# UNITED STATES PATENT AND TRADEMARK OFFICE

APPLICATION NO.	FILING DATE	FIRST NAMED INVENTOR	ATTORNEY DOCKET NO.	CONFIRMATION NO.
09/887,337	06/25/2001	In Duk Song	8733.425.00	5925

# Office Action Summary

2. **Claims 1, 2 and 6-16 are rejected under 35 U.S.C. 102(e) as being anticipated by Komatsu, USPAT 6,335,770.**

**FIG.5**

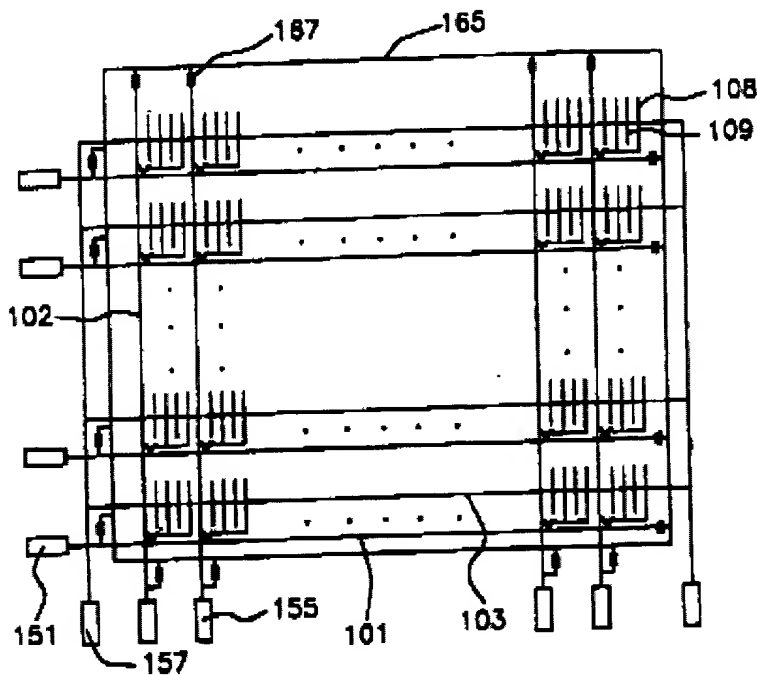
3. Komatsu discloses in col. 5, lines 40-65 and shows in Fig. 5 (reproduced below), an in-plane switching type liquid crystal display device comprising:

- a plurality of data lines (102) for applying data signals to a thin film transistor array;
- a plurality of gate lines (101) for applying gate signals to the thin film transistor array;
- a plurality of gate links extended from the plurality of gate lines (101) into an outer area of the thin film transistor array; and
- a plurality of common voltage lines connected to common voltage pads (157), being provided in such a manner to cross the plurality of gate links, for applying a common voltage to the thin film transistor array.

Komatsu also shows in Fig. 5 that the common voltage lines are parallel to the gate lines (101).

As to claim 7, Komatsu shows in Fig. 5 that the in-plane switching liquid crystal display device further comprising:

- a plurality of gate pads (151) connected to the gate links and electrically disposed between the gate links and an external power source; and
- a plurality of common voltage pads (157) connected to the common voltage lines and electrically disposed between the common voltage lines and the external power source.

As to claims 8-11 and 14, Fig. 5 of Komatsu also shows that the gate pads (151), data pads (155) and the common voltage pads (157) are located in an area outside of the thin film transistor array.

As to claims 12 and 13, Komatsu also shows in Fig. 5 that at least one common line that is parallel to the data line (102) crosses the gate lines (101) in an area between the gate pads (151) and the thin film transistor array.

As to claims 15 and 16, Komatsu shows in Fig. 5 that at least one common line crosses the data lines (102) in an area between the data pads (155) and the thin film transistor array.

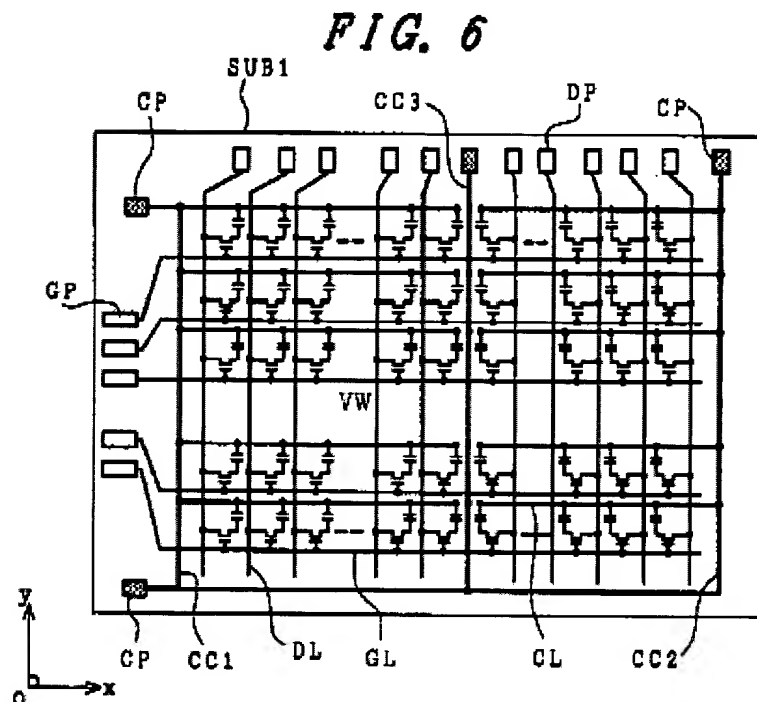
5. Ashizawa discloses in col. 9, lines 27-67 and shows in Fig. 6, an in-plane switching type liquid crystal display device comprising:

- a plurality of data lines (DL) for applying data signals to a thin film transistor array;
- a plurality of gate lines (GL) for applying gate signals to the thin film transistor array;
- a plurality of gate links extended from the plurality of gate lines (GL) into an outer area of the thin film transistor array; and

- a plurality of common voltage lines (CC1, CC2) connected to common voltage pads (CP), being provided in such a manner to cross the plurality of gate links, for applying a common voltage to the thin film transistor array.

Ashizawa also shows (Fig. 6) that plurality of gate pads (GP) that are located outside of the thin film transistor array are connected to the gate links and electrically disposed between the gate links and an external power source.

Ashizawa also shows (Fig. 6) that a plurality of data pads (DP) are connected to the data links.

Ashizawa further shows (Fig. 6) that a common voltage line is parallel to the data lines (DL) and a common voltage line is parallel to the gate line (GL).
